Addendum No. 3 to IFB 16-48

To: All Parties on Record with the City of Somerville as Holding **IFB 16-48**
Cedar St Sewer Separation

Re: Extended Due Date, Revised Unit Price Form, Updated Specifications, Select, Revised Drawings/Plans

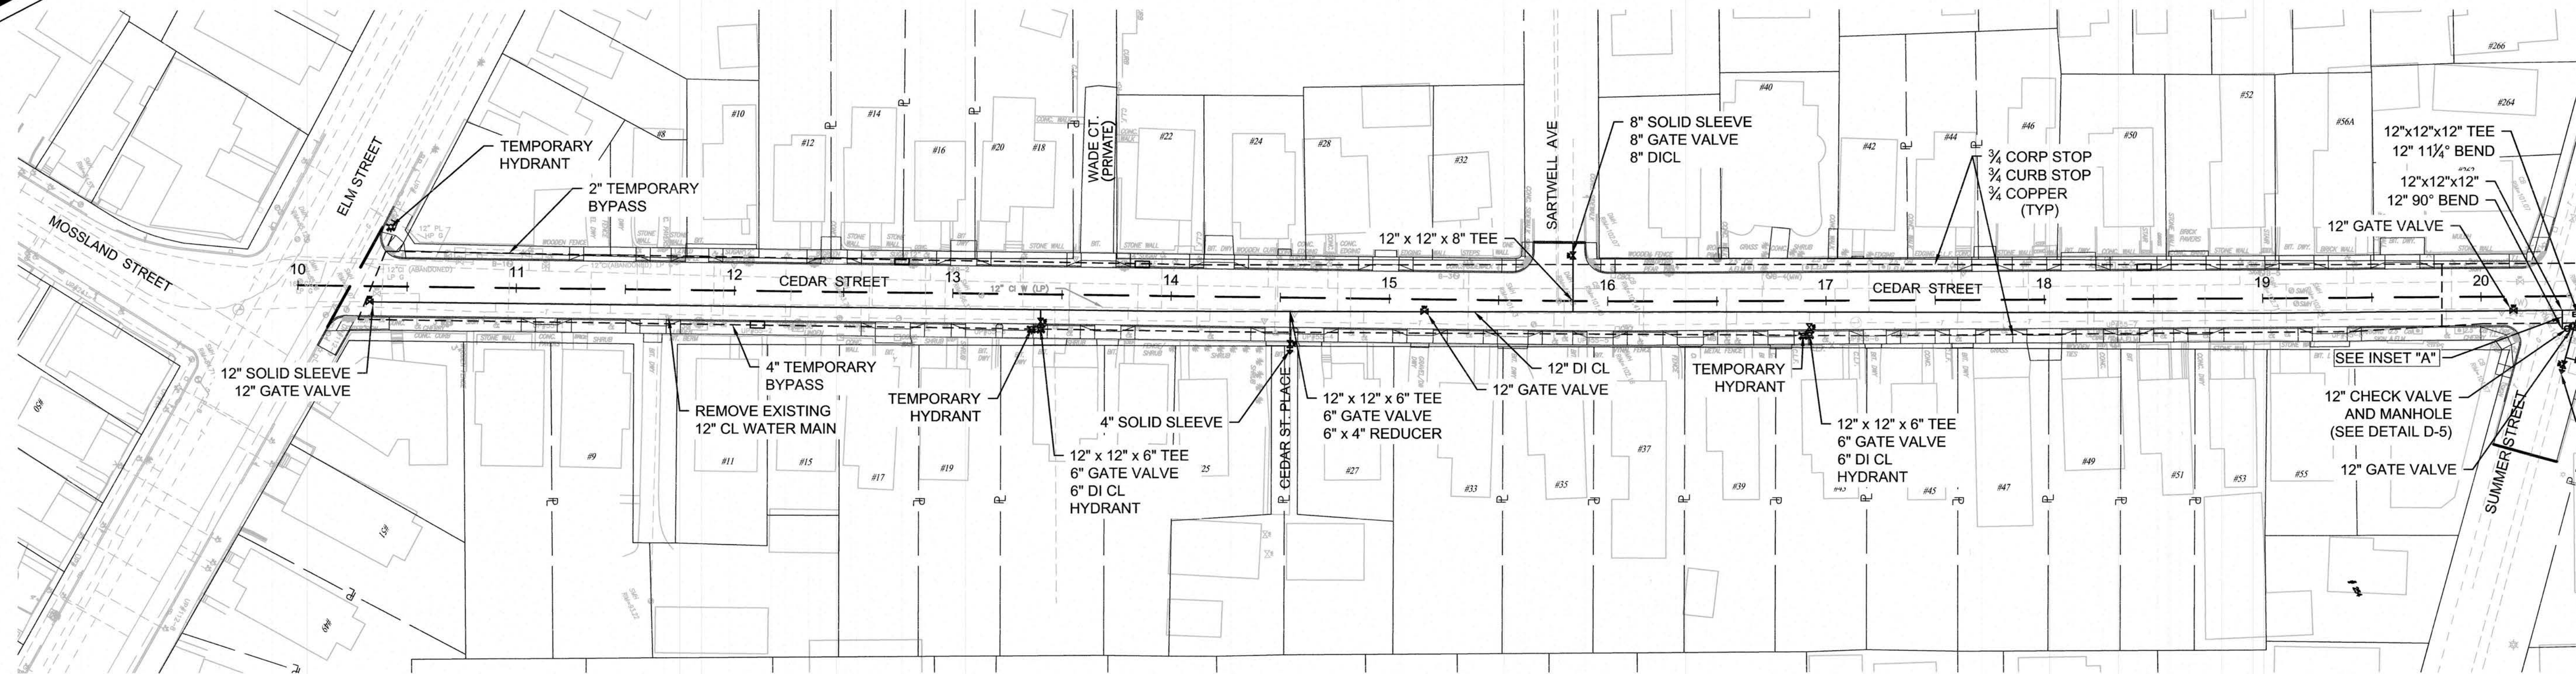
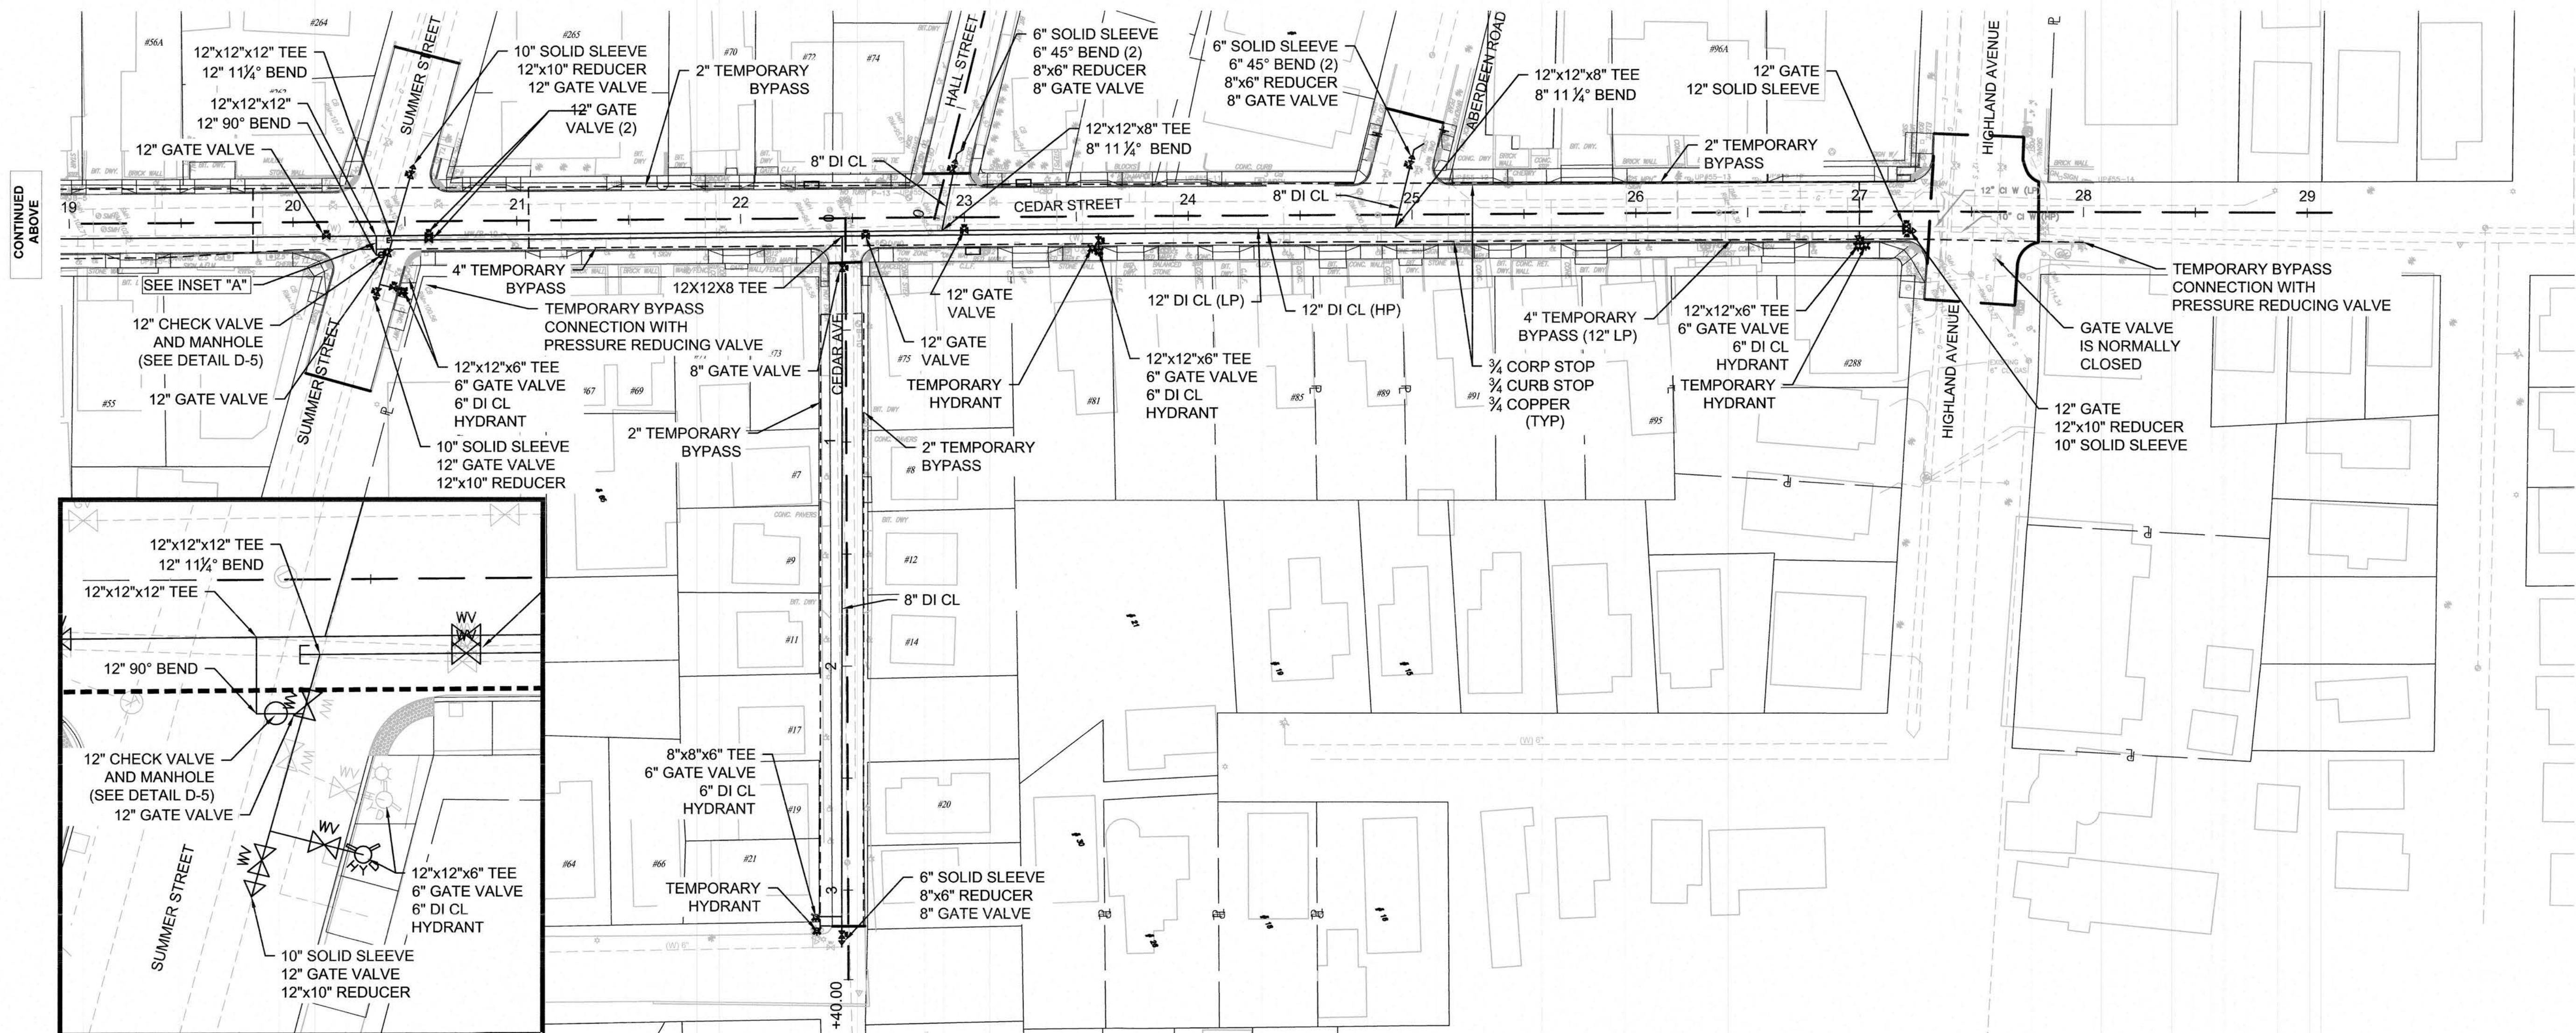
Q: Item 7c-12” DIP Water Main-2,493 Feet. The only 12’ water main is shown on Drawing S-10, therefore the estimated quantity is incorrect as the stationing is 10+50-27+25 and a 12” connection on Summer Street. Please clarify.

ROADWAY CONSTRUCTION PLAN AND PROFILE

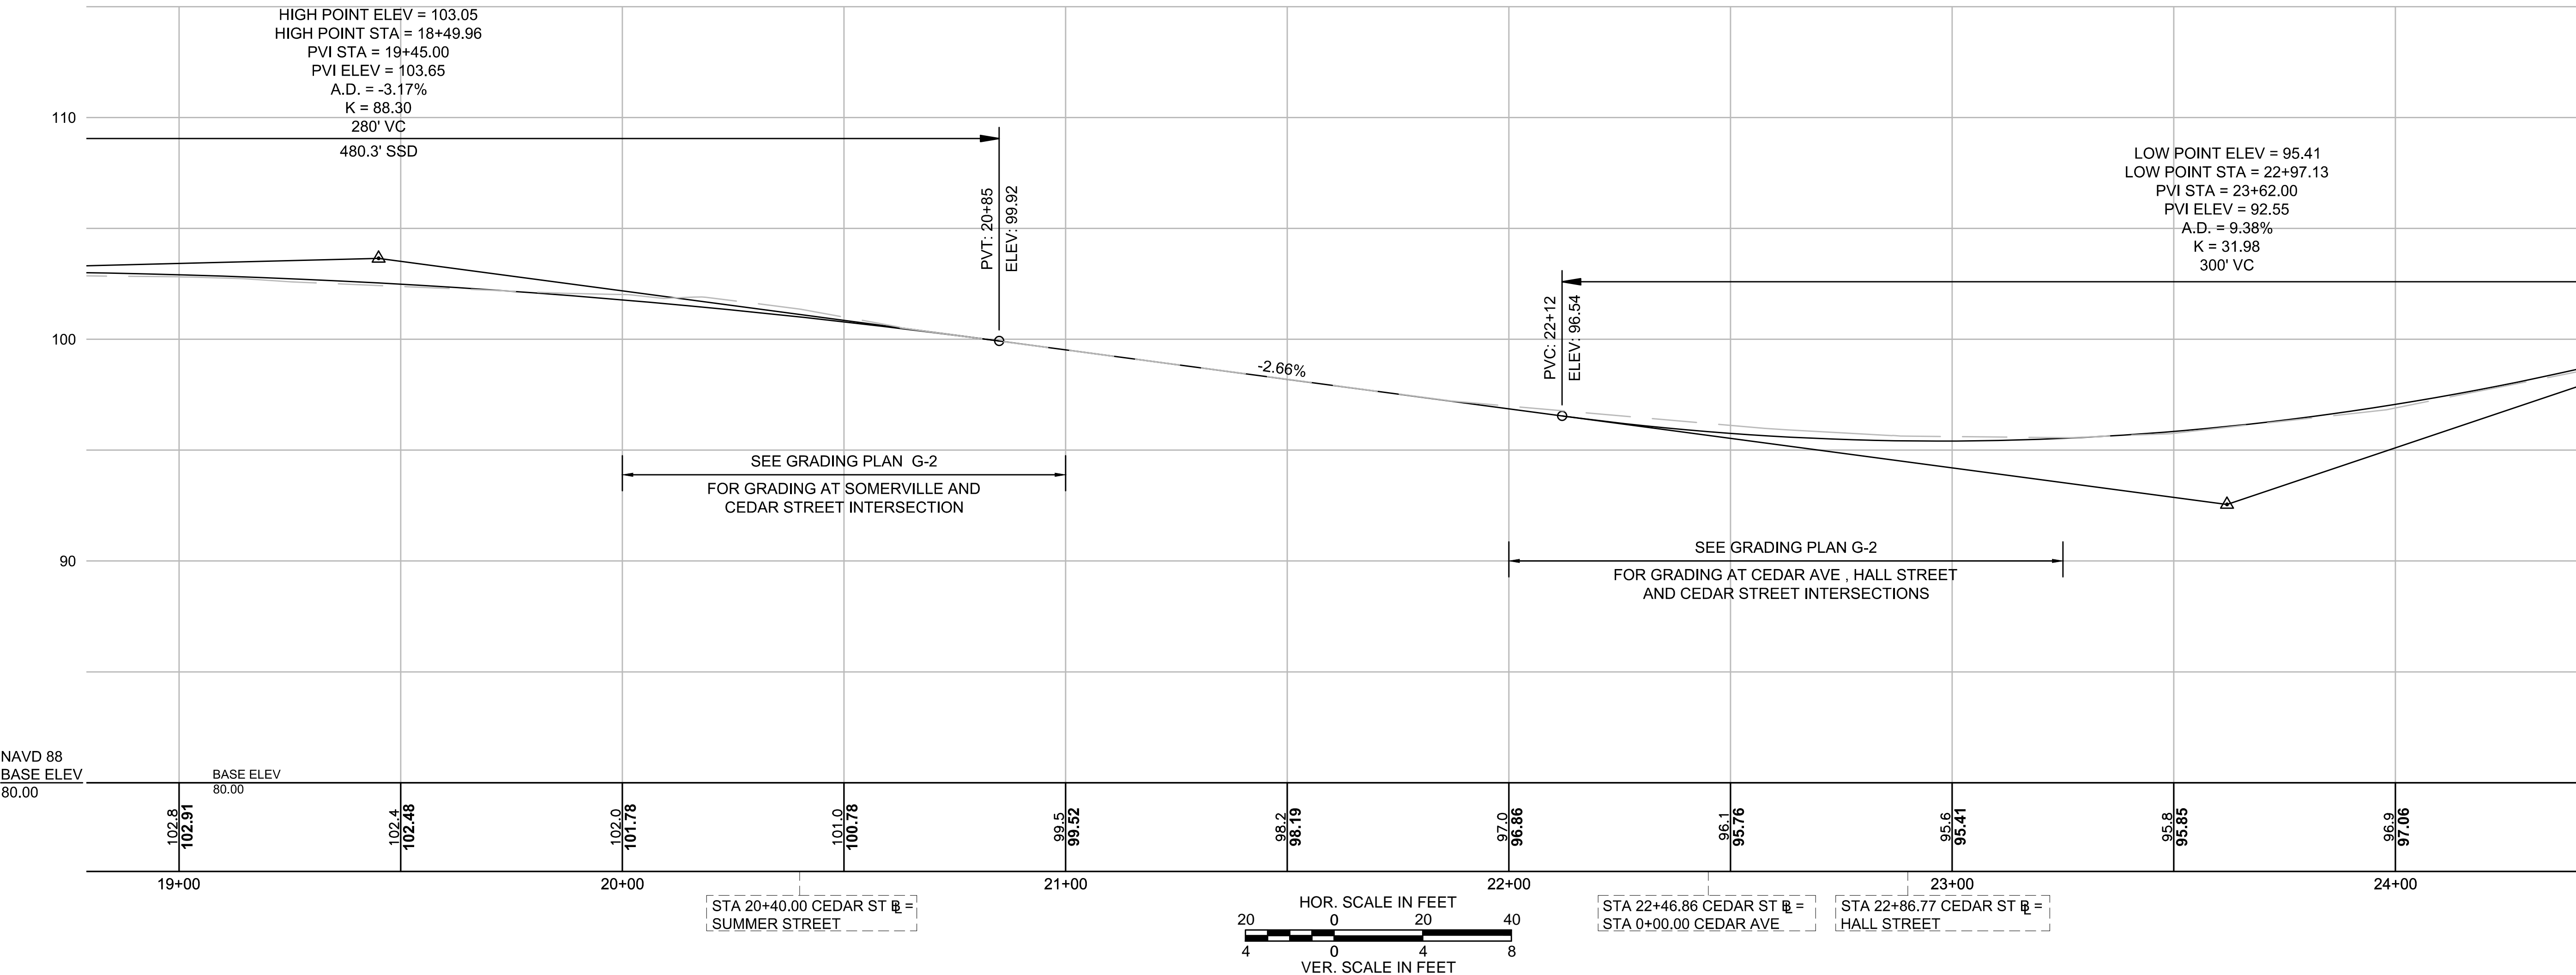
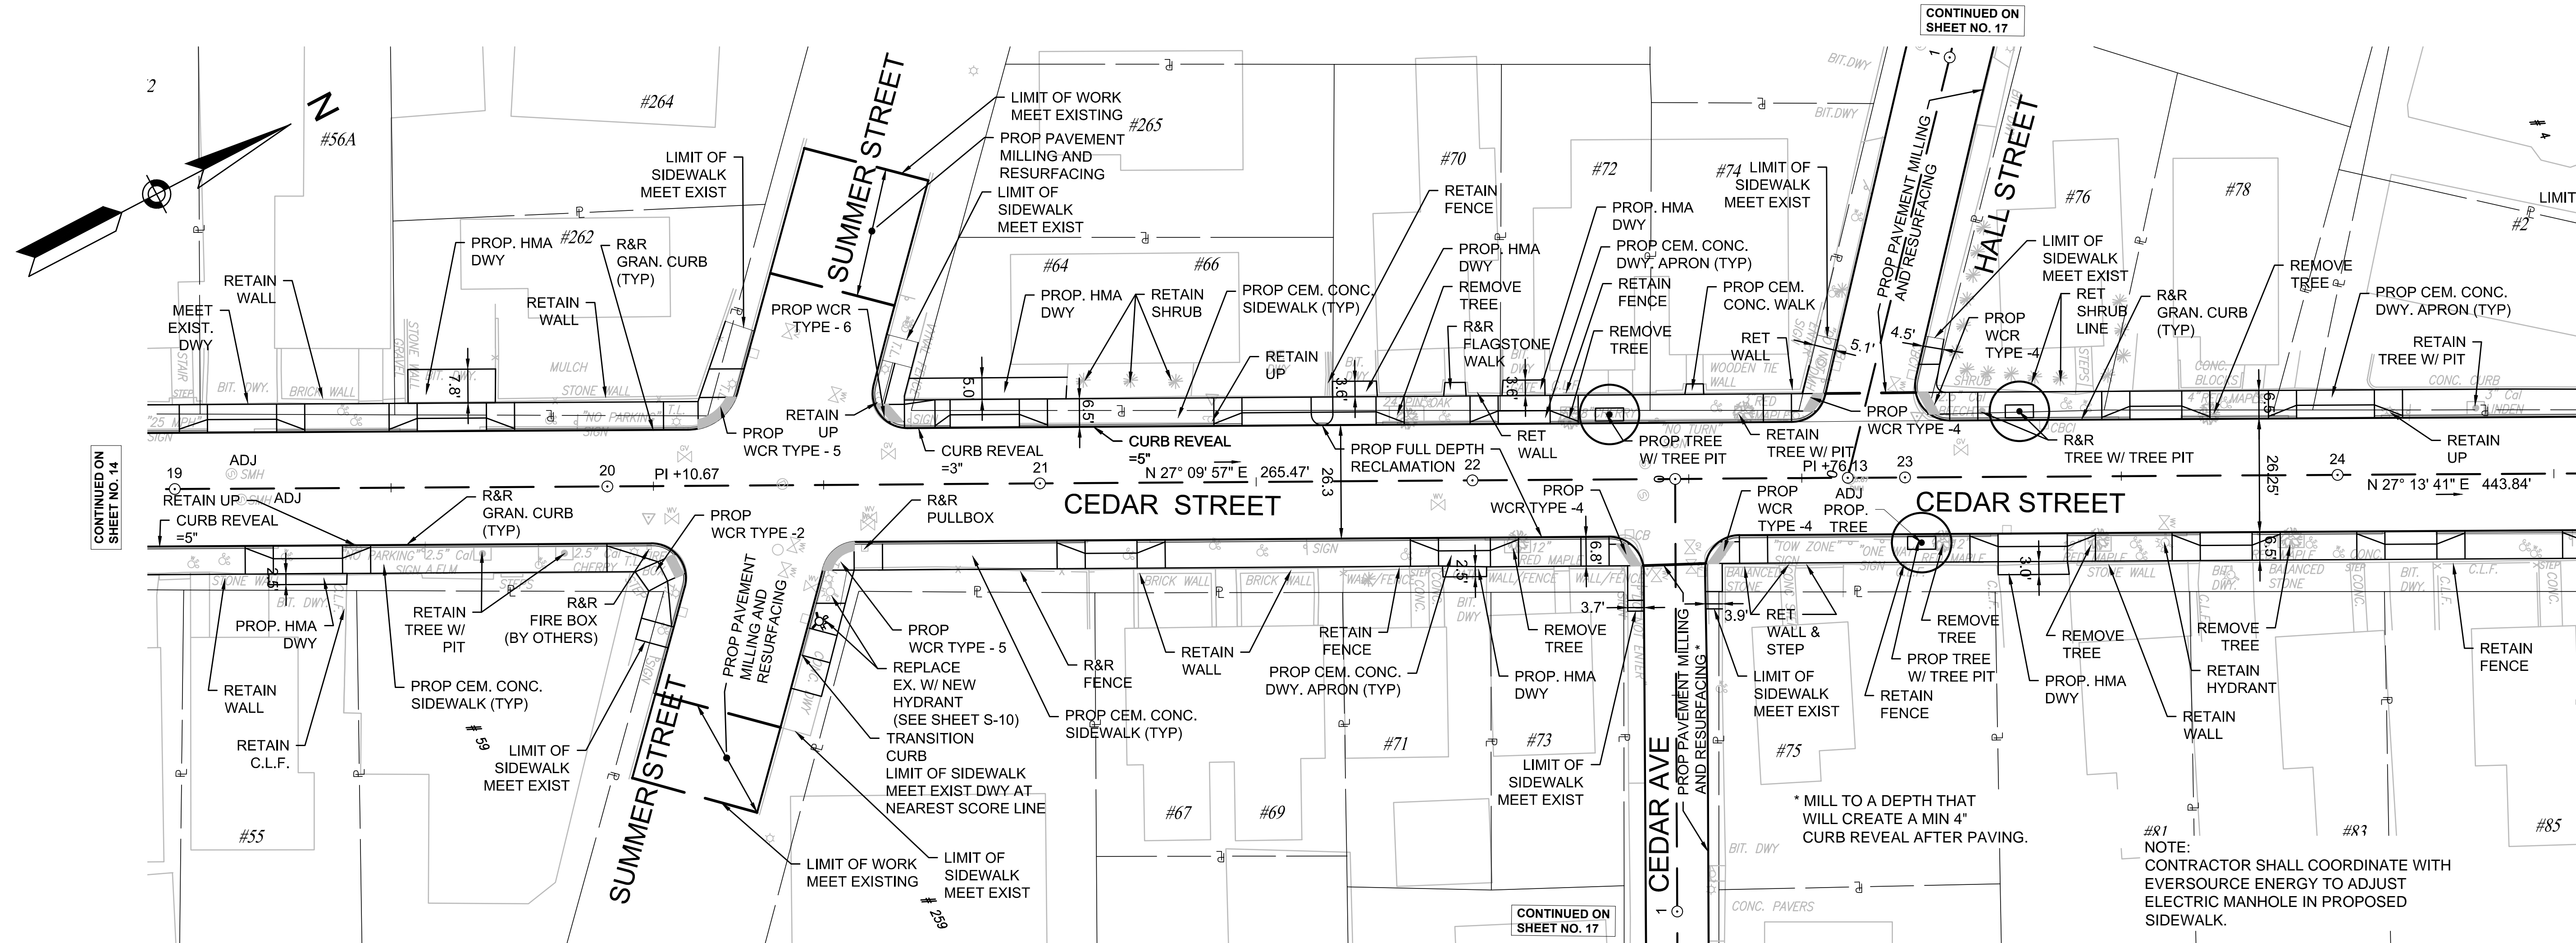
Q: Drawing C-5 shows saw cutting to the Limits of Work of Highland Ave., but there are no notes showing what work is required. Please clarify.

A: *The intersection at Highland Avenue shall be milled and resurfaced. This work is shown on the revised Sheet C-4 included herein (Attachment 3).*
